[Docket No. FAA-2007-28661; Directorate Identifier 2007-NM-013-AD]

Airworthiness Directives; The Boeing Company Model 737-600, -700, -700C, -800, and -900 Series Airplanes

ACTION: Supplemental notice of proposed rulemaking (NPRM); reopening of comment period.

Figure 1

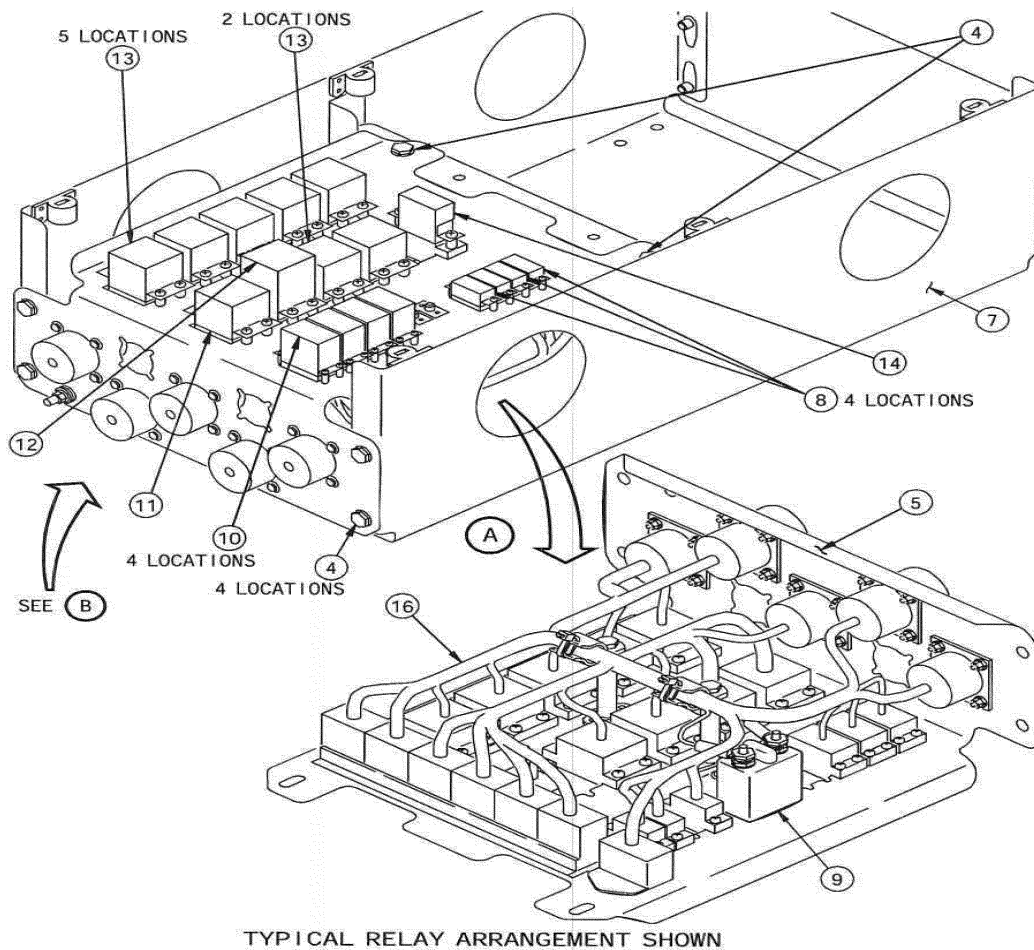
- Sheet 2 of 4 of Figure 11 of Boeing Alert Service Bulletin 737-28A1206, Revision 2, dated May 21, 2009, was inadvertently replaced with Sheet 2 of 4 of Figure 11 from Boeing Alert Service Bulletin 737-28A1206, dated January 11, 2006. That figure was corrected in Boeing Alert Service Bulletin 737-28A1206, Revision 1, dated January 30,

2008, and did not need to be changed in Boeing Alert Service Bulletin 737–28A1206, Revision 2, dated May 21, 2009. We have added Figure 1 in this supplemental NPRM to provide the correct Sheet 2 of 4 of Figure 11.
